MOTORCYCLE 7/10/02 M2002-016

RECALL

2002 XV1700PCP, PCPCFACTORY MODIFICATION CAMPAIGN

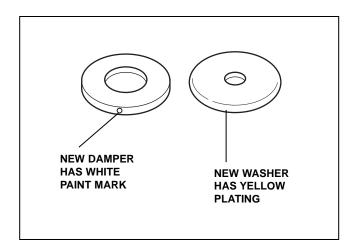
Yamaha Motor Corporation, USA has determined that a defect which relates to motor vehicle safety exists in 2002 XV1700PCP and XV1700PCPC ("Road Star Warrior") motorcycles. In affected motorcycles, the fuel tank bracket washer and damper do not adequately protect the tank from engine vibration. Over a period of time, vibration might damage the tank which could result in a fuel leak with the possibility of fire.

1. Remove the seat, air induction system cover, and fuel tank.

2. Replace the original fuel tank bracket washer and damper with the modified ones.

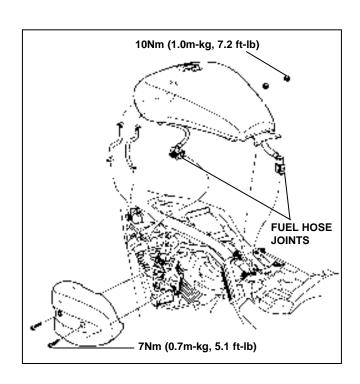
♠WARNING

Be sure the two fuel hose joints are connected securely.
